MINERALS PROGRAM INSPECTION REPORT
PHONE: (303) 866-3567

MINE NAME: Gunnison River Gravel Pits	MINE/PROSPECTING ID#: M-2009-048	MINERAL: Sand and gravel	COUNTY: Mesa
INSPECTION TYPE: Surety-Related Inspection	WEATHER: Clear	INSP. DATE: February 12, 2025	INSP. TIME: 14:30
OPERATOR: CW Construction, LLC	OPERATOR REPRESENTATIVE: Tim Loncarich	TYPE OF OPERATION: 112c - Construction Regular Operation	
REASON FOR INSPECTION: Surety Release Requested	BOND CALCULATION TYPE: Complete Bond	BOND AMOUNT: \$91,664.00	
DATE OF COMPLAINT: NA	POST INSP. CONTACTS: None	JOINT INSP. AGENCY: None	
INSPECTOR(S): Amy Yeldell	INSPECTOR'S SIGNATURE: 	SIGNATURE DATE: February 21, 2025

Photo 3: Main scarp on west side of Pit 5

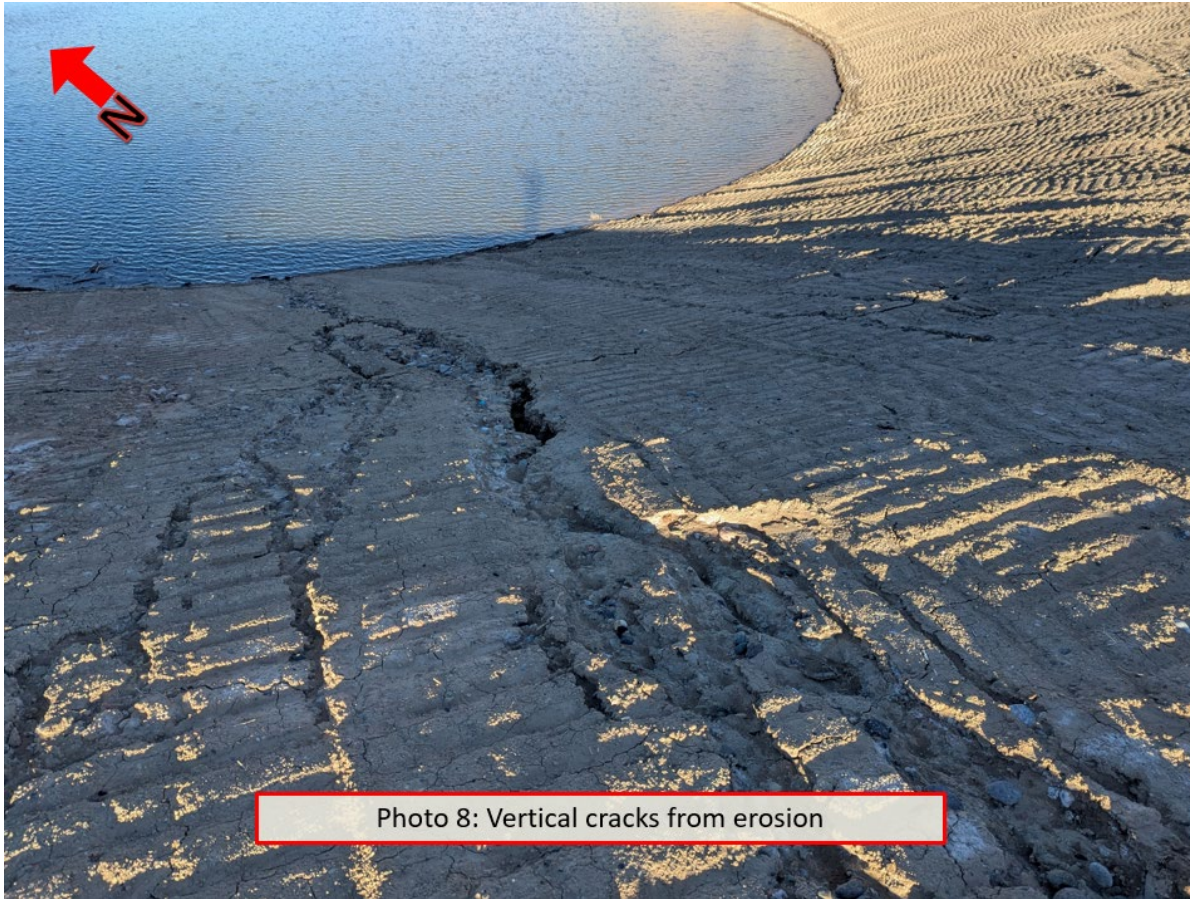
PROBLEM: Placement of backfill material and grading was not completed in a manner that avoids unacceptable settling and voids per Rule 3.1.5(9)(f). Furthermore, overburden was not adequately compacted for stability. For these reasons slope stability with regards to backfilling and grading is cited as an inspection problem.

Backfilling and grading were completed in late 2024 for Pit 5. Upon cessation of pumping the pit has begun to fill and lower soils along the toe slope have become saturated. This in combination with time appears to have resulted in differential settling (horizontal cracks). To some extent this is to be expected and natural. But it also could be exacerbated by improper compaction of backfilled areas and/or utilizing poor backfill materials which results in voids over time. Most notable a large scarp is present on the west side of the pit which is approximately 100 yards long by 4 inches wide and in excess of 24 inches deep. Photos three through five. The slip surface is approximately 18 inches lower than the head of the scarp at its deepest point and is gradually less towards the edges. Several smaller secondary slumps were also observed within the main scarp. No toe bulge was observed but is likely present below the water level. Additional layered slumps were observed to the south of the main scarp, photo six. Several smaller settling cracks were observed throughout the other highwalls of Pit 5, Photo Seven. These cracks varied in length but were generally only a few inches wide and less than 24 inches deep with no drop in the slip surface.

CORRECTIVE ACTIONS: All slopes in Pit 5 with surface cracking shall be regraded and compacted to a sufficient depth to removed differential settling expressions and ensure sufficient compaction to prevent future occurrences to the extent practical. Pursuant to Rule 3.1.5(7) and the approved Reclamation Plan all slopes shall be no steeper than a 3H: 1V. Where insufficient material is present on site to complete contouring additional inert fill may need to be imported to establish proper grade. If import material is brought in topsoil may also be required to provide sufficient vegetative growth material. Additionally, until slope stability issues are resolved pumping should resume as needed to maintain current water levels within Pit 5. Both written and photographic documentation of the above mentioned actions shall be completed and submitted to the Division by the corrective action due date.
